ZONING BOARD OF ADJUSTMENT MEETING

Request HV19-21 of Tim Shaffer dba Dale's Service Center at 3816 W. Locust Street for a hardship variance to waive curbing requirements along the north and west perimeter of the parking lot and to reduce the width of a buffer yard from 15 to 7.5 feet along the east property line. Sections 17.11.080.A.2 and 17.10.030.E require parking lots to be designed with curbing and buffer yards when abutting landscape, walkways, or structures and residential districts, respectively. [Ward 1]

City of Davenport
Community Planning & Economic Development Department
STAFF EXHIBITS & REPORT

SITE LAYOUT PLAN
SCALE: 1" = 20'-0"

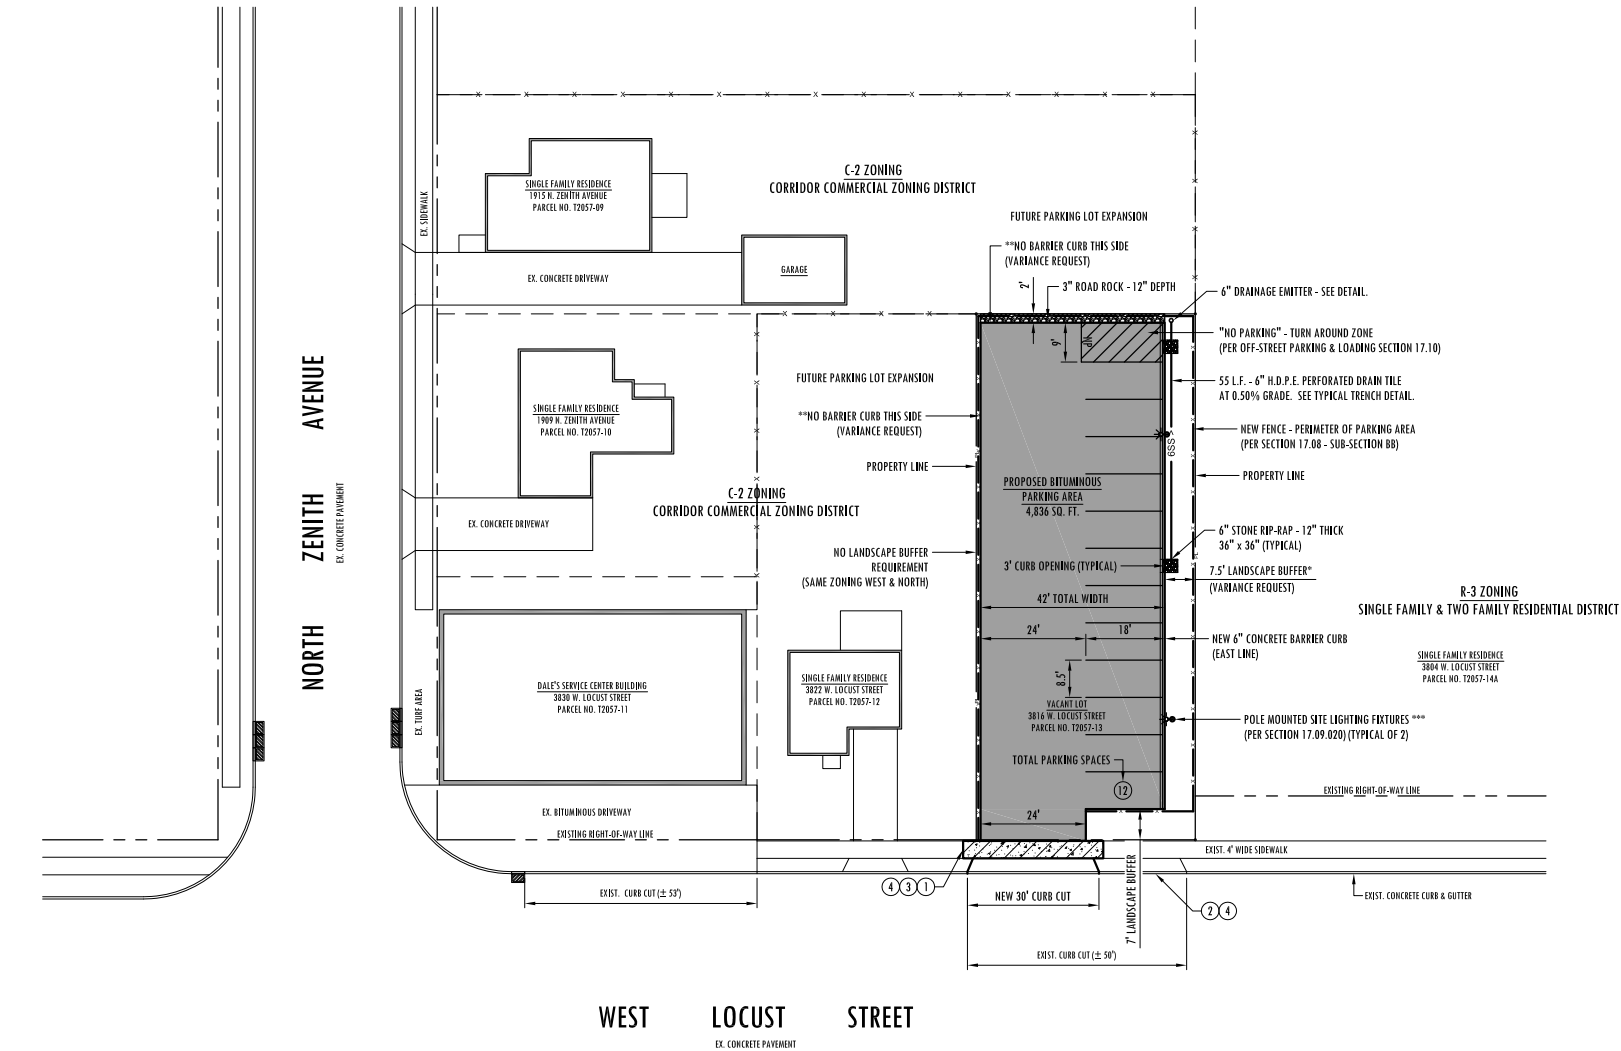
Section 17.080 - Sub-Section C (Item 1)
Variance from the 15 foot landscape buffer zone to a 7.5 foot landscape buffer zone.
Adjacent property to east of project is zoned R-3 (Single Family & Two-Family Residential District) where the variance is requested.
Variance requested for purposes of required space to meet design standards for off-street parking lots.
Current lot width is 50 feet.
Section 17.10.30 - Sub-Section E (Item 1)
Variance from required curb construction along the North & West sides of the project.
Future parking development will be added to the proposed project that would require the removal of such curbs in these areas.

****VARIANCE REQUEST - SECTION 17.080 - SUB-SECTION C (ITEM 1)**
C-2 ZONING ADJACENT TO R-3 ZONING REQUIREMENT VARIANCE FROM THE 15 FT. LANDSCAPE BUFFER YARD REQUIREMENT TO A 7.5 FT. LANDSCAPE BUFFER YARD ON THE EAST SIDE OF THE NEW PARKING AREA TO MEET PARKING LOT REQUIREMENTS FOR TWO-WAY AISLE WIDTH & STALL WIDTH & DEPTH DIMENSIONS. THE PARCEL WIDTH (50 FT.) LIMITS PRACTICAL APPLICATION OF ALL DIMENSION REQUIREMENTS BEING APPLIED.

****VARIANCE REQUEST - SECTION 17.10.30 - SUB-SECTION E (ITEM 1)**
VARIANCE FROM CURBING REQUIREMENT ON WEST & NORTH PARKING LOT SIDES FOR FUTURE PARKING LOT EXPANSION IN THESE AREAS. STORM WATER RUN-OFF WILL BE DIVERTED TO THE LANDSCAPE BUFF AREA. SEE SHEET C-2 FOR DRAINAGE PATTERNS.

- 1 . perimeter parking lot curbing shall be installed within seven years or alternatively, curbing shall be constructed in the future parking areas depicted on the site plan when those areas are available to the petitioner for development, whichever comes first.
